## PIC16F684 Rev. A Silicon/Data Sheet Errata

The PIC16F684 parts you have received conform functionally to the Device Data Sheet (DS41202D), except for the anomalies described below.

**FIGURE 8-2: COMPARATOR C1 OUTPUT BLOCK DIAGRAM**

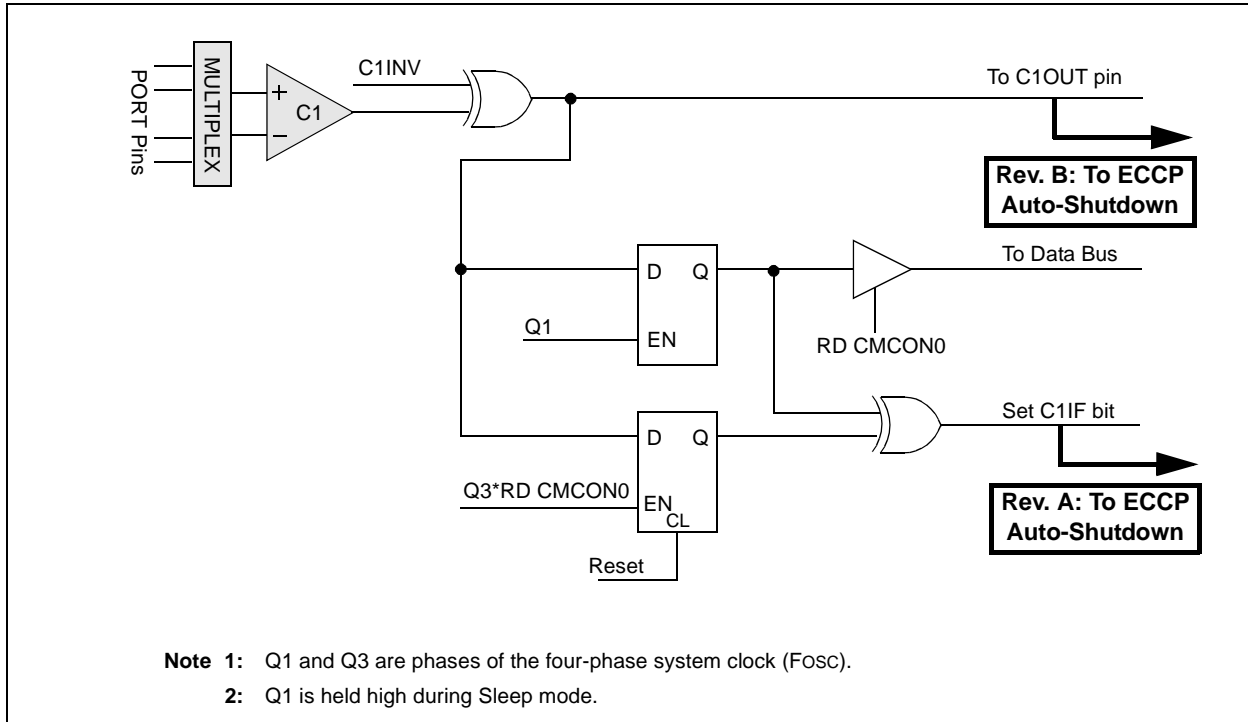
The PIC16F684 Rev. A4 silicon for the ECCP Auto-Shutdown is connected to the C1IF and C2IF flags. See Figures 8-2 and 8-3 on the following page.

Rev. A4's auto-shutdown connection to C1IF and C2IF causes the auto-shutdown to incorrectly operate synchronously. Additionally, reads of CMCON0 will incorrectly clear an auto-shutdown event.

- 1) Poll the CxOUT bit until it is low.
- 2) Read CMCON1 to precondition CxIF.
- 3) If CMCON0 is read while CxOUT is changing, repeat steps 1 and 2.

**FIGURE 1: SILICON REVISION A4 VS. REVISION B2**

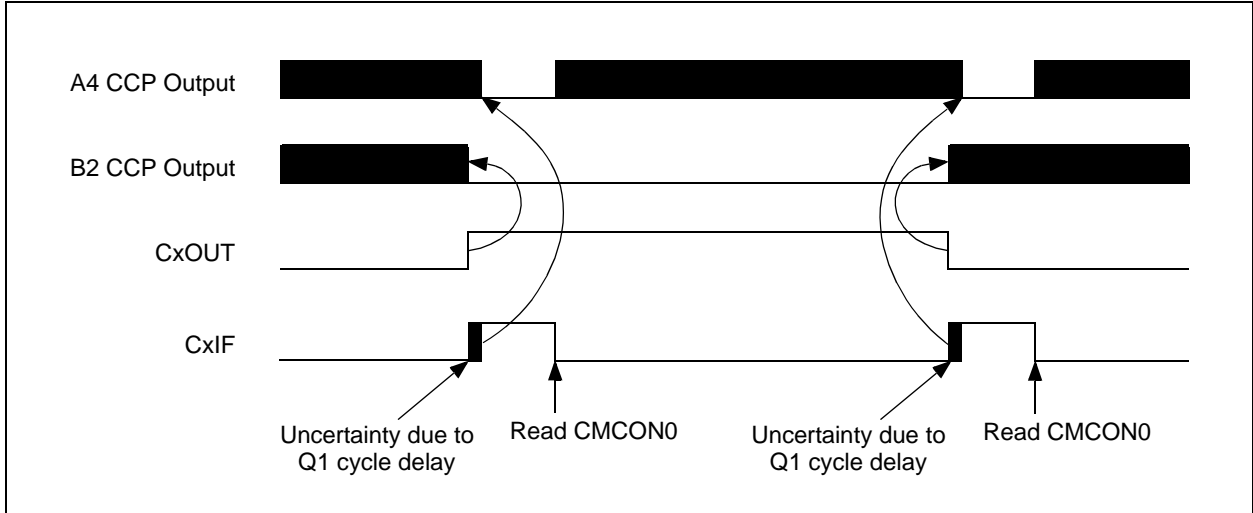
The Silicon Rev. B2 device (now shipping) has moved the auto-shutdown connection from CxIF to CxOUT. This will eliminate the synchronous shutdown and simplify the use of the comparator for a shutdown event. Figure 1 shows the function of auto-shutdown before and after the device revision.
